Access Compliance Report

Public Rights-of-Way

(Curb Ramps)

Intersection ID: 50609	Main Street: DOWNY_BIRCH_RD	Cross Street: PADDLE_OAK_RD	Location: NW
ADA ID: F4C5642A153E	Ramp Type: Perp	Initial Pass/Fail: Fail	Overall Compliance: No
Severity Score: 12.5			
Codes/Mitigation Info/Possible Solution		Field Measurements/Component Compliance

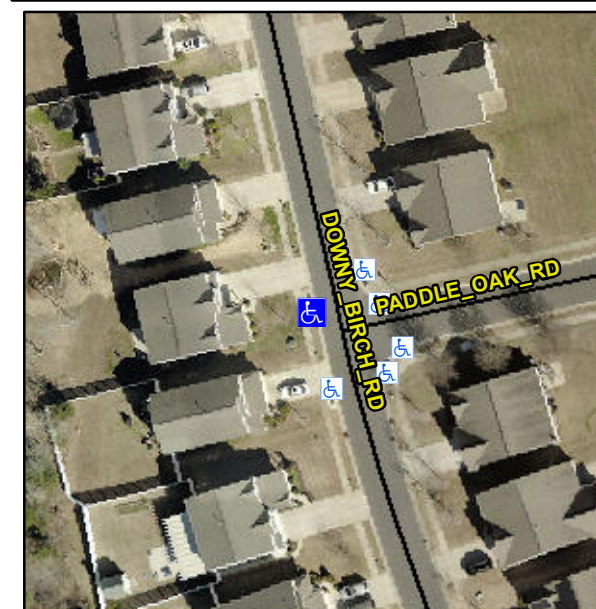
Not Found, R304.2.2

Compliance	Description	Data	Compliance	Description	Data
N/A	Ramp Length (in)	47.0	No	Ramp Slope (%)	9.0
Yes	Ramp Width (in)	48.0	Yes	Ramp XSlope (%)	1.4
N/A	Flare Type LT	N/A	N/A	Flare Type RT	N/A
N/A	Flare Slope LT (%)	N/A	N/A	Flare Slope RT (%)	N/A
N/A	Flare Traversable LT?	N/A	N/A	Flare Traversable RT?	N/A
N/A	Landing Length (in)	N/A	N/A	DWS Provided?	N/A
N/A	Landing Width (in)	N/A	N/A	DWS Contrast?	N/A
N/A	Landing Slope (%)	N/A	N/A	DWS Length (in)	N/A
N/A	Landing X Slope (%)	N/A	N/A	DWS Full Width?	N/A
N/A	Landing Curb? (Y/N)	N/A	N/A	DWS Offset (in)	N/A
N/A	Shared Landing?	N/A			
N/A	Gutter Ponding?	N/A	N/A	Gutter Slope (%)	N/A
N/A	Gutter Lip Ht (in)	N/A	N/A	Gutter X Slope (%)	N/A
N/A	Painted X Walk1?	No	N/A	Painted X Walk2?	N/A
	X Walk 1 Direction	To E		X Walk 2 Direction	N/A
N/A	X Walk 1 Width (in)	N/A	N/A	X Walk 2 Width (in)	N/A
	X Walk 1 Slope (%)	2.9		X Walk 2 Slope (%)	N/A
	X Walk 1 X Slope (%)	1.7		X Walk 2 X Slope (%)	N/A

Remove & Replace Entire Ramp.
